Nomad

SERVICE BULLETIN

TRANSMITTAL LETTER
FOR
SERVICE BULLETIN NMD-55-5

**HORIZONTAL STABILISER — VERTICAL FIN AND TRIM TABS —
STRUCTURAL AND OPERATING MECHANISM INSPECTION
AND MODIFICATION**

VIEW ON L.H.S. AIRCRAFT (DORSAL REMOVED)

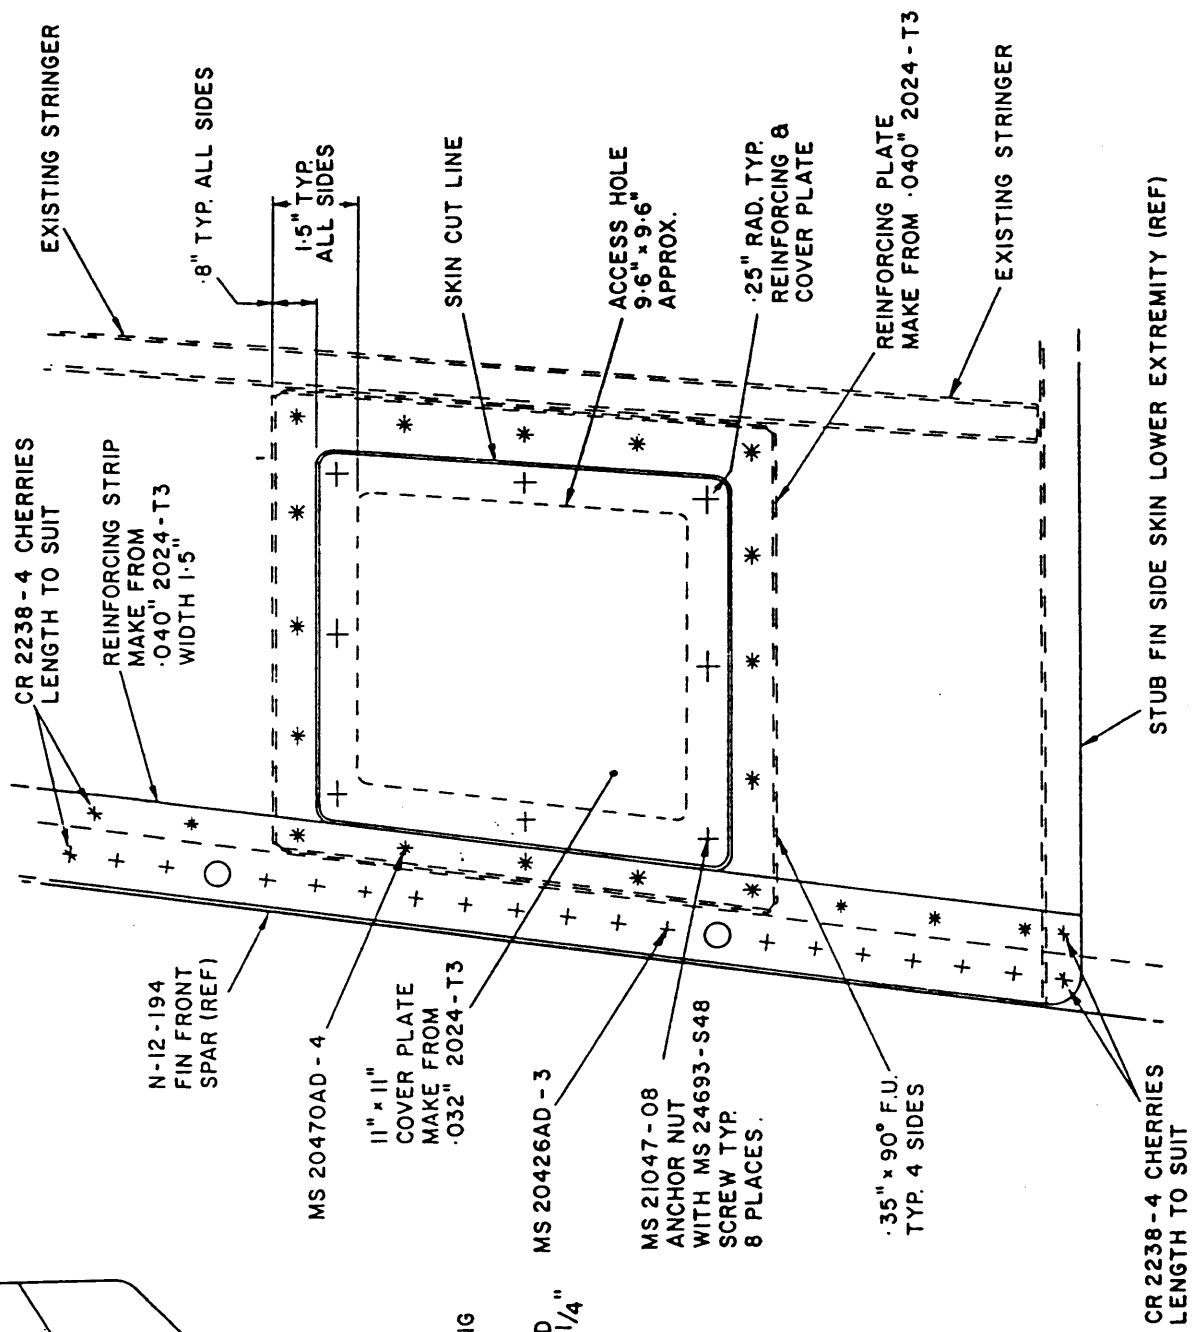
- Part 3.
- a. Rework left side of stub fin to provide access panel (Ref. Fig. 1).
 - b. Remove countersunk rivets where side skins attach stub fin forward spar (on both sides of fin). Attach reinforcing strips to rivet line of side skins at stub fin forward spar using rivets as detailed in Fig. 1.
 - c. Using torch and mirror carry out visual inspection of internal stub fin structure. In particular inspect vertical stringer emanating from rudder lower hinge doubler.
 - d. Vertical stringers: Replace or repair in accordance with Structural Repair Manual 53-10-11 Fig. 2.
 - e. Manufacture and install "Z" stiffener as detailed in Fig. 2.

DE-RIVET ALONG SPAR
 FLANGE LINE - ATTACH
 REINFORCING STRIP PICKING
 UP EXISTING HOLES.
 INSTALL 15 EQUALLY
 SPACED RIVETS IN SECOND
 ROW, MIN EDGE DISTANCE 1/4"
